## **Packet Guide**

### **Regular Meeting**

**B. Consent Agenda**

Revised Landscape Plan — staff notations

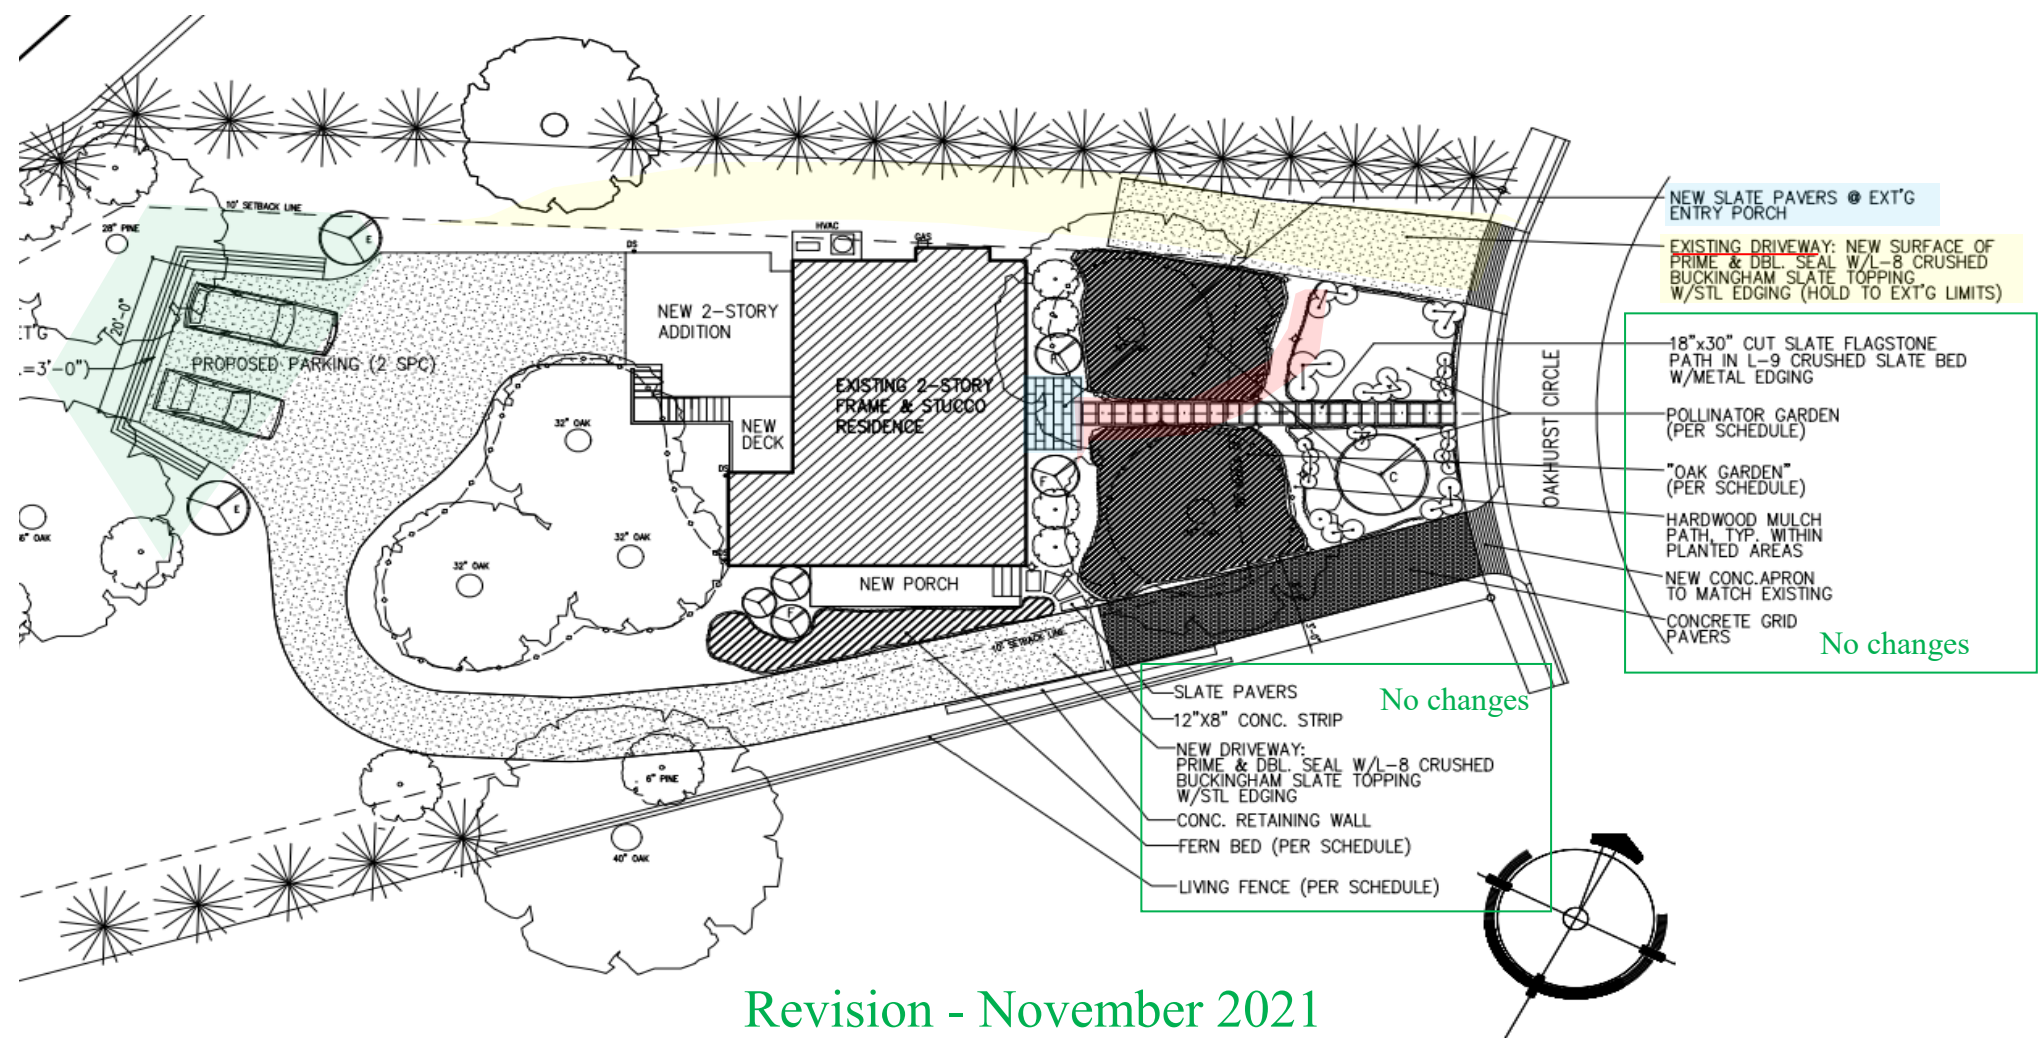
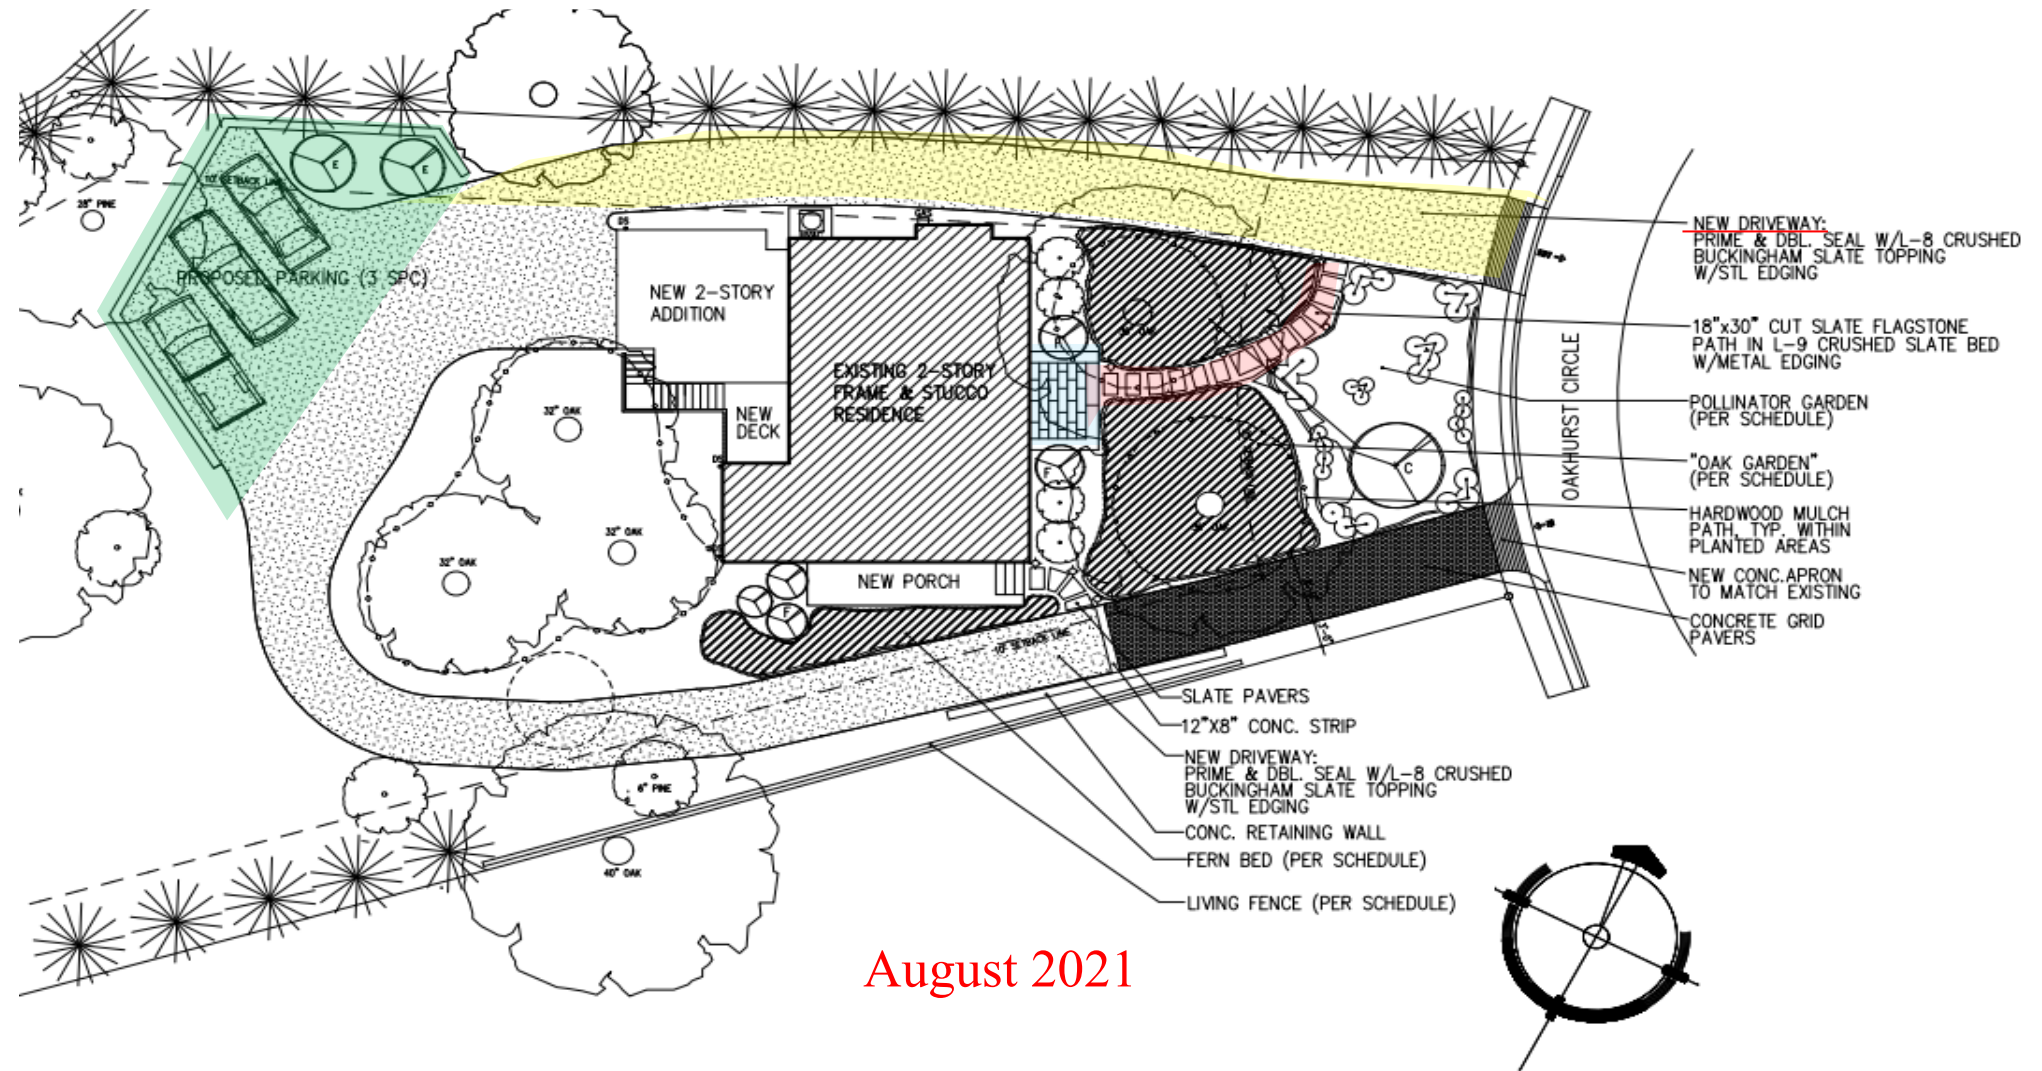
- Remove: 6” Crepe Myrtle (front), 6” Dogwood (front), 4” Holly (rear), ~~40” Oak (rear)\*.~~
- New: See Plant Schedule on Sheet A. (*Rain Garden, Ferns, Oak Garden, Living Fence/Green Screen, Pollinator Garden.*)
- Hardwood mulch within planting areas.

*Approval:* Having considered the standards set forth within the City Code, including City’s ADC District Design Guidelines, I move to find that the proposed landscaping plan for 106 Oakhurst Circle satisfies the BAR’s criteria and is compatible with this property and other properties in the Oakhurst-Gildersleeve ADC District, and that the BAR approves the application [as submitted]. Additionally, the BAR recommends the city traffic engineer allow flexibility relative to the required driveway entrance width. Of particular concern, to extent possible, is preservation of the existing granite curb stones.

BUILDING FOOTPRINT DIAGRAM

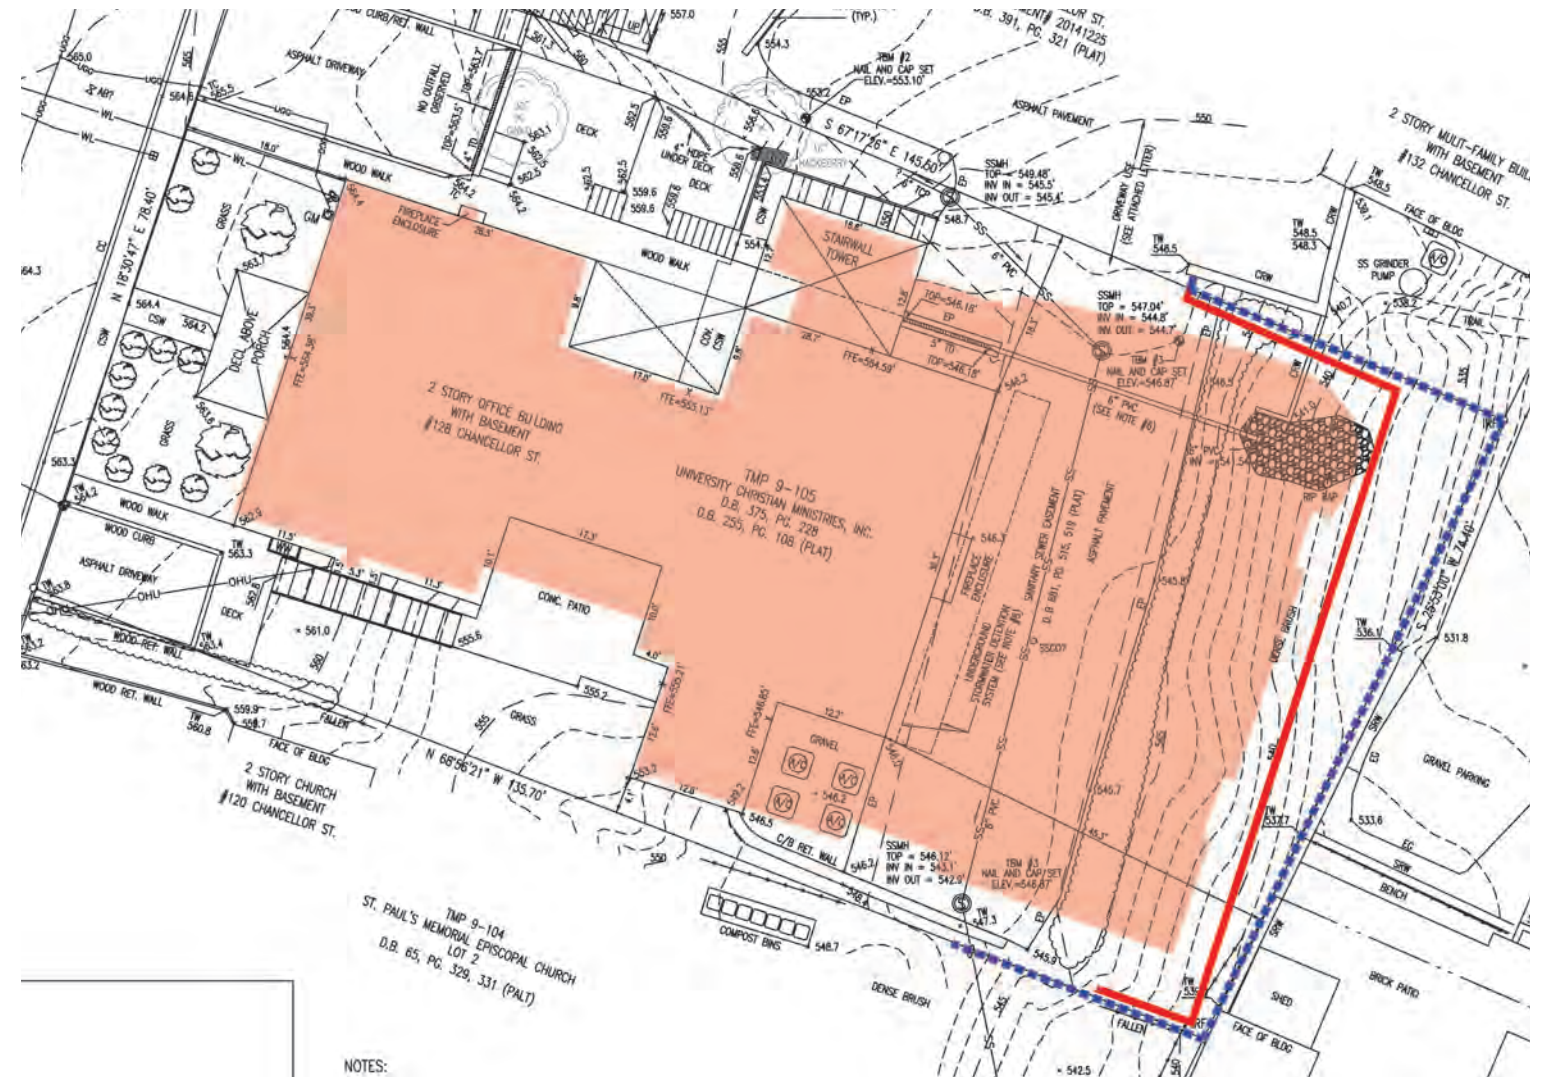
- Reduce the square footage of the main and upper levels by reducing the distance the cantilever out toward the east. The footprint of the parking level remains unchanged.
- Reduce the number of windows on the north and south elevation.
- Change the East retaining wall material to engineered stacked block from concrete.
- Move the east retaining back away from the east property line; and addition of low-gro fragrant sumac as ground cover/buffer between the stacked block retaining wall and the properties on Elliewood Avenue.
- Relocate the guard fence from the top of the retaining wall to be in line with the face of the building as the area between the retaining and building is not accessible.

Staff finds the proposed modifications are consistent with the prior BAR approvals and recommends approval.

Brick Pavers to match existing chimney

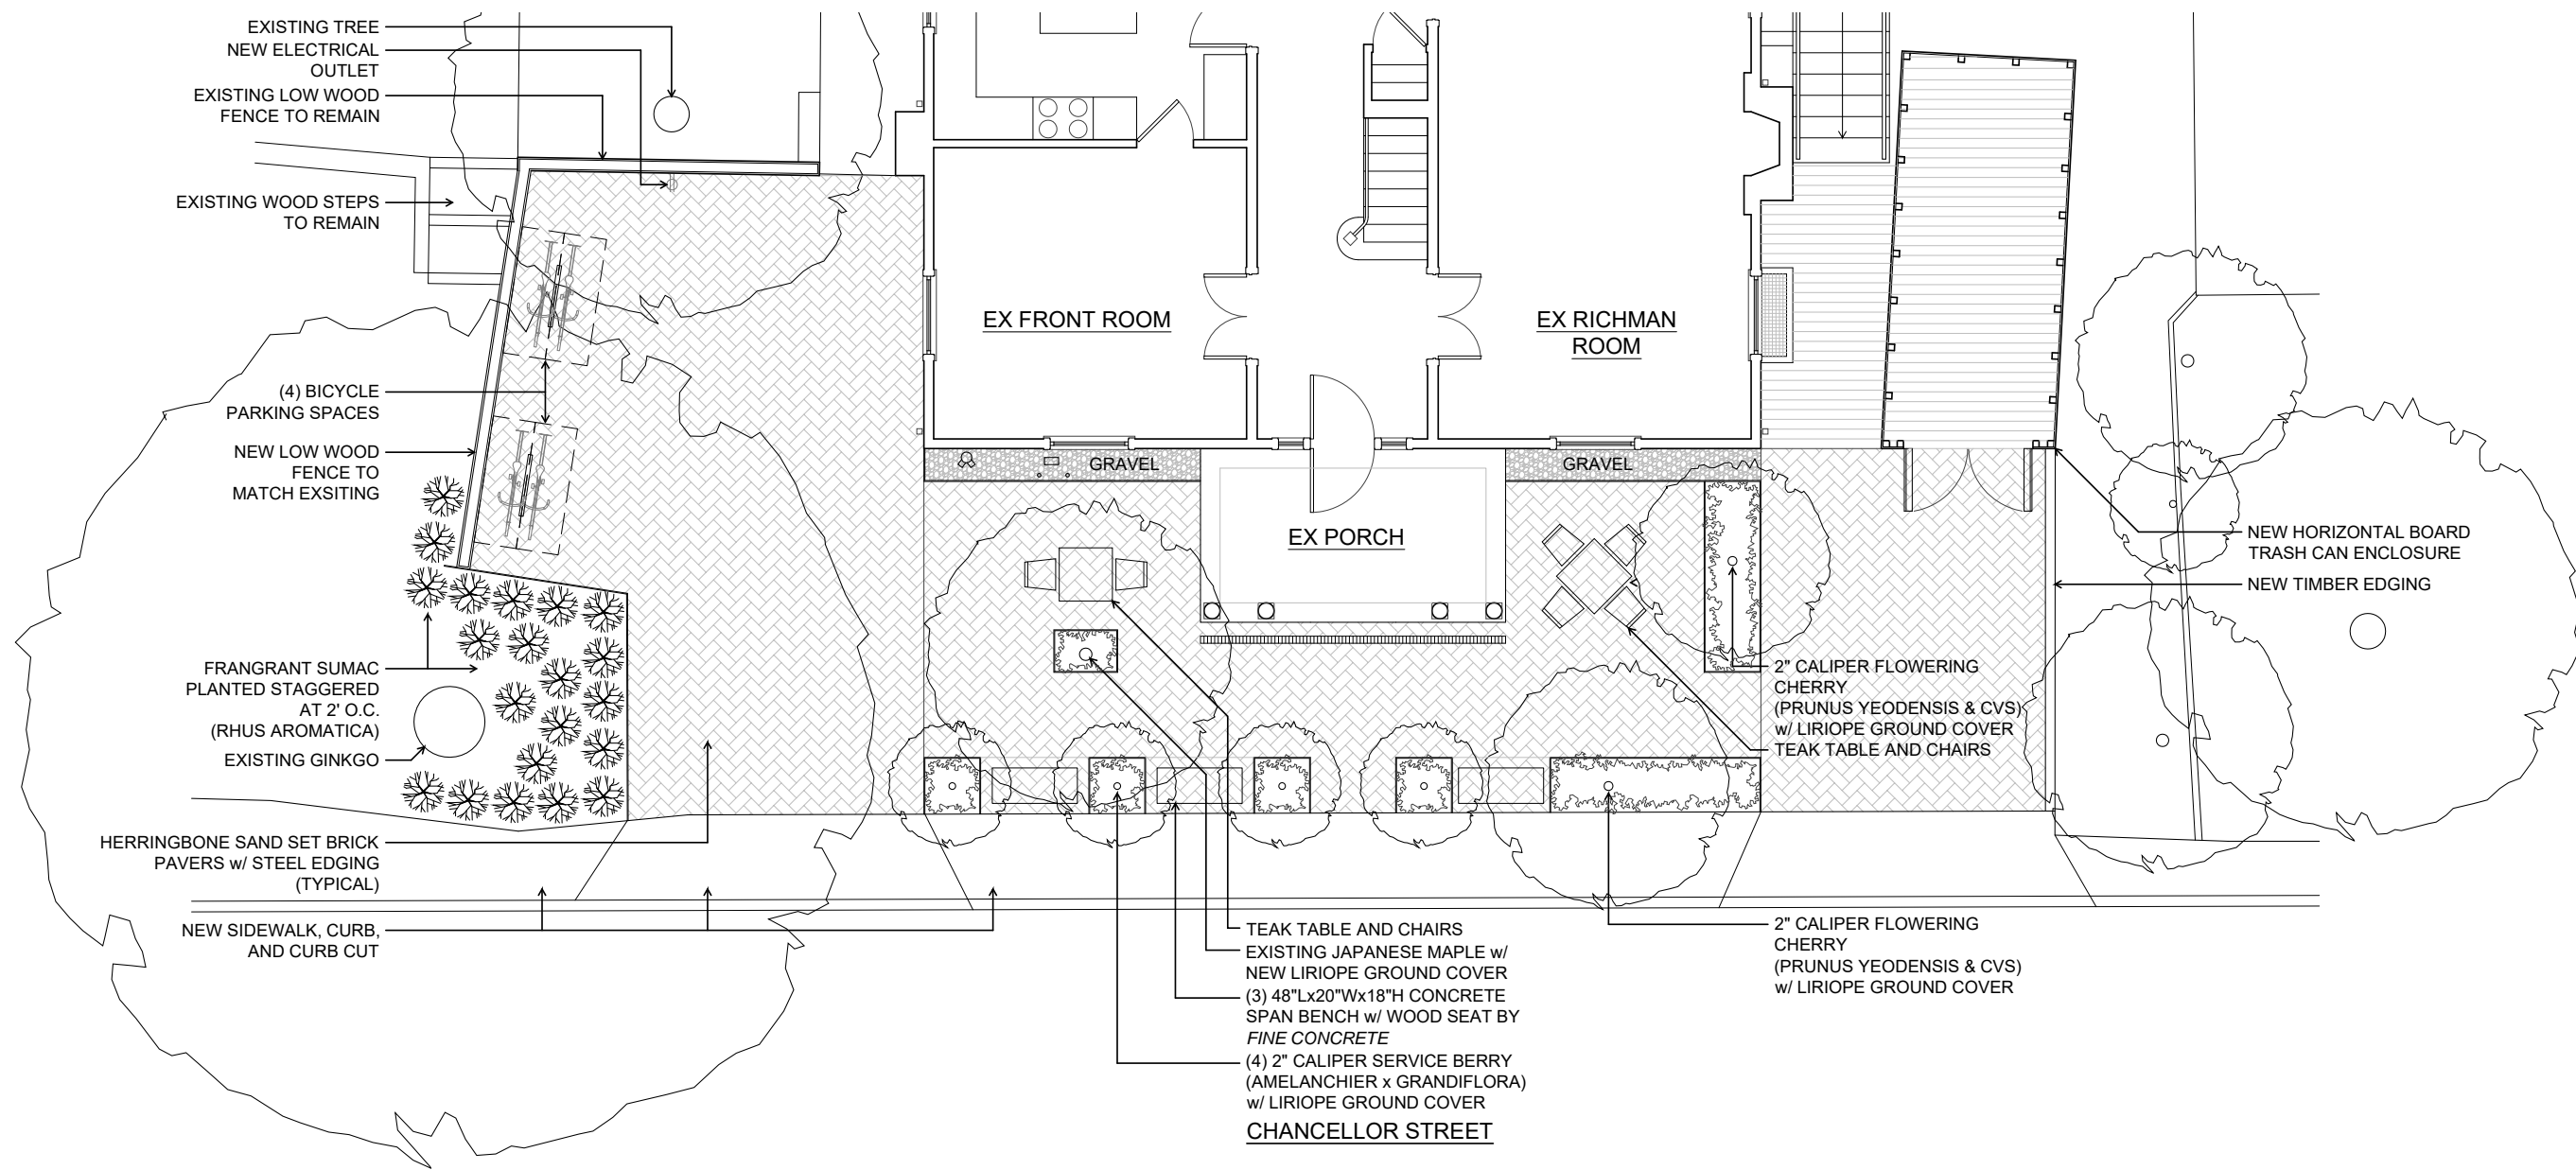
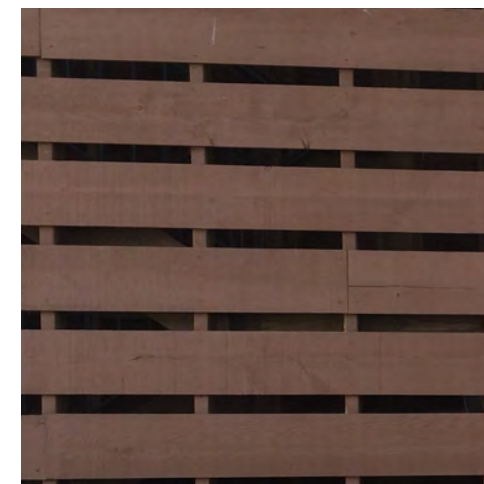
- Relocate the bike racks from the back of the building to along the northern edge of the new brick terrace at the front of the building. This will likely reduce the number of cars parked in the northern half of the terrace from four cars to two cars.
- Plant low-gro fragrant sumac around the existing Ginkgo tree in the northwest corner of the site.
- Remove the planter boxes along the sidewalk from the project in their entirety and in their place provide permanent planting beds with a mix of four (4) serviceberry and two (2) cherry trees planted amidst liriop.
- Reduce the number of benches along the sidewalk to three (3) 4-foot benches and delete the wooden bench around the existing Japanese maple (upon further review of the health of tree there was not enough clearance for the bench.)

One solution would be to move the benches 2 feet closer to the house or change their orientation from parallel to the street to perpendicular.

We also still don't understand how the city would allow the Center to put brick pavers down in the front yard. They have essentially built out every square inch of the property, with very little green space, creating potential water runoff issues. One can only hope that the planners have adequately addressed this problem.
